Low Temp Test procedure for EVs

ACEA TF EV input for SG EV meeting on February 13th

Test Procedure (PEV) – Shortened Test Procedure or Consecutive Cycle Procedure

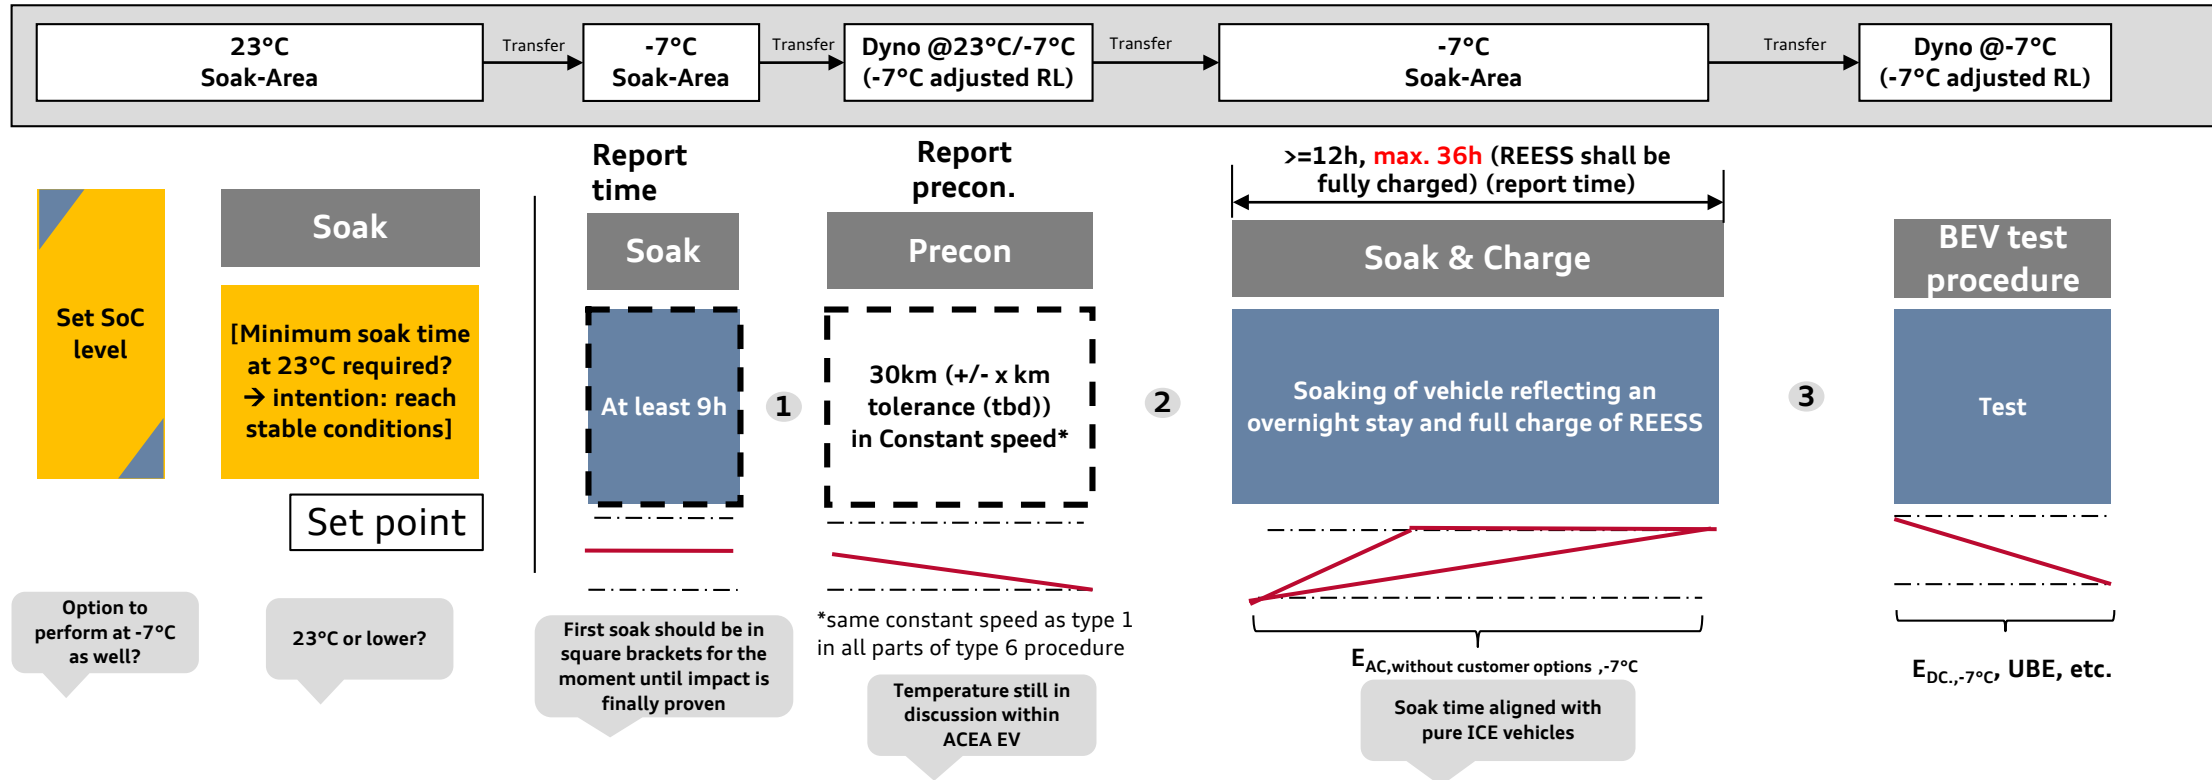
Proposal ACEA TF EV (based on submitted one with slight modification in PreCon + proposal to put first soak in [...]):

- 1 Leaving soak (-7°C) until starting PreCon test in test cell (-7/23°C): max.: [40] min (transfer: max. [20] min, preparation on dyno: max. [20] min)
→ Without any unjustified delay
- 2 End test cycle (-7°C) and placing in soak (-7°C): max.: [30] min where max. [20] min for transfer
→ without any unjustified delay, connecting to grid within max. [30] min
- 3 Leaving soak (-7°C) until starting test in test cell (-7/23°C): max.: [40] min (transfer: max. [20] min, preparation on dyno: max. [20] min)
→ Without any unjustified delay; vehicle shall not receive unjustified exposure to temperatures higher than -7°C; in case that is unavoidable, this shall not be longer than [20] min
→ Note: only max. [30] min between different tests on the dyno shall not be exceeded (only related to dyno warm-up)

Test Procedure (OVC-HEV) – Charge Depleting Test

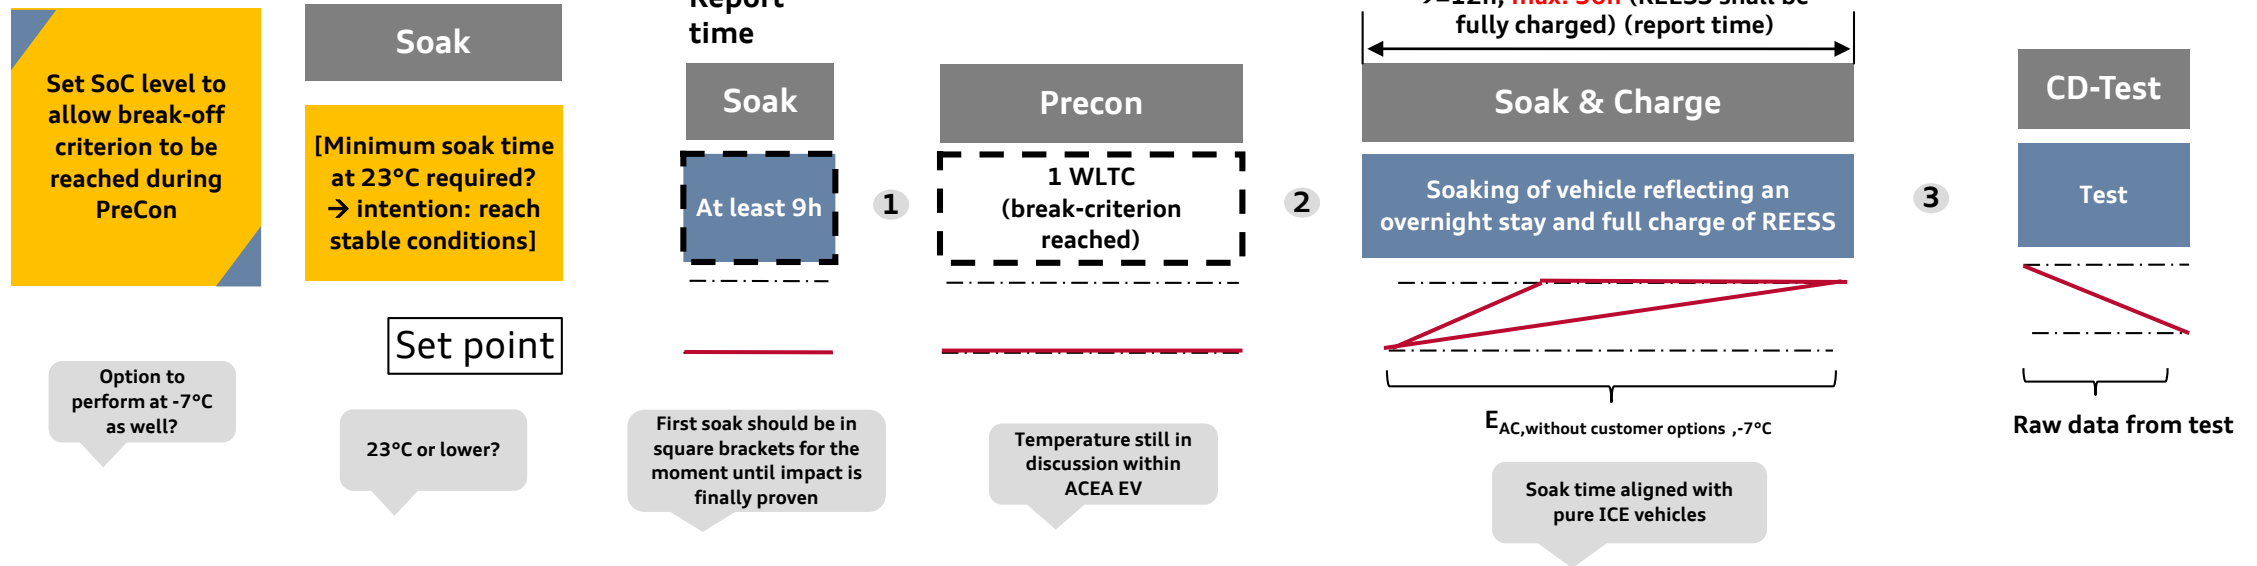
Proposal ACEA TF EV (based on submitted one with slight modification in PreCon + proposal to put first soak in [...]):

- 1 Leaving soak (-7°C) until starting PreCon test in test cell (-7/23°C): max.: [40] min (transfer: max. [20] min, preparation on dyno: max. [20] min)
→ Without any unjustified delay
- 2 End test cycle (-7°C) and placing in soak (-7°C): max.: [30] min where max. [20] min for transfer
→ without any unjustified delay, connecting to grid within max. [30] min
- 3 Leaving soak (-7°C) until starting test in test cell (-7/23°C): max.: [40] min (transfer: max. [20] min, preparation on dyno: max. [20] min)
→ Without any unjustified delay; vehicle shall not receive unjustified exposure to temperatures higher than -7°C; in case that is unavoidable, this shall not be longer than [20] min
→ Note: only max. [30] min between different tests on the dyno shall not be exceeded (only related to dyno warm-up)
